# Access Compliance Report

## Public Rights-of-Way

### (Curb Ramps)

Intersection ID: 13959	Main Street: CLEVELAND_AV	Cross Street: E_PARK_AV	Location: E
ADA ID: 6C996EF69A93	Ramp Type: PerpDiag	Initial Pass/Fail: Fail	Overall Compliance: No
		Severity Score: 12.5

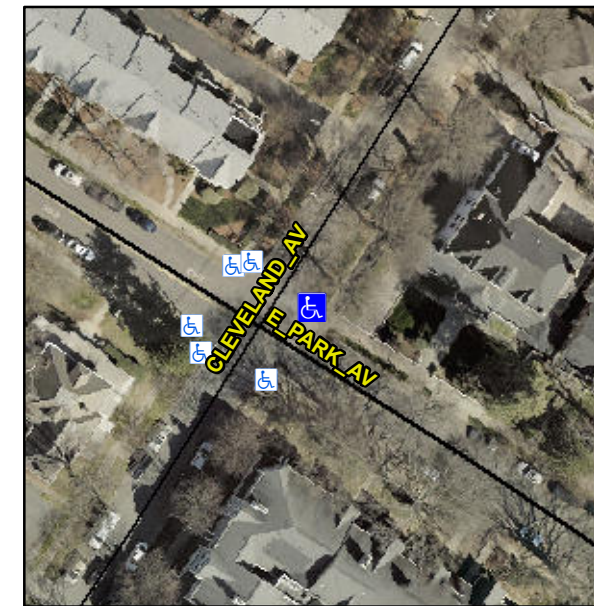
**R304.2.2**

Compliance	Description	Data	Compliance	Description	Data
N/A	Ramp Length (in)	140.0	No	Ramp Slope (%)	8.6
Yes	Ramp Width (in)	67.0	Yes	Ramp XSlope (%)	0.1
N/A	Flare Type LT	N/A	N/A	Flare Type RT	N/A
N/A	Flare Slope LT (%)	N/A	N/A	Flare Slope RT (%)	N/A
N/A	Flare Traversable LT?	N/A	N/A	Flare Traversable RT?	N/A
N/A	Landing Length (in)	N/A	N/A	DWS Provided?	N/A
N/A	Landing Width (in)	N/A	N/A	DWS Contrast?	N/A
N/A	Landing Slope (%)	N/A	N/A	DWS Length (in)	N/A
N/A	Landing X Slope (%)	N/A	N/A	DWS Full Width?	N/A
N/A	Landing Curb? (Y/N)	N/A	N/A	DWS Offset (in)	N/A
N/A	Shared Landing?	N/A			
N/A	Gutter Ponding?	N/A	N/A	Gutter Slope (%)	N/A
N/A	Gutter Lip Ht (in)	N/A	N/A	Gutter X Slope (%)	N/A
N/A	Painted X Walk1?	No	N/A	Painted X Walk2?	No
	X Walk 1 Direction	To NW		X Walk 2 Direction	To SW
N/A	X Walk 1 Width (in)	N/A	N/A	X Walk 2 Width (in)	N/A
	X Walk 1 Slope (%)	4.9		X Walk 2 Slope (%)	6.2
	X Walk 1 X Slope (%)	3.7		X Walk 2 X Slope (%)	1.4

**Remove & Replace Curb Ramp With Two New Directional Ramps or Equivalent.**
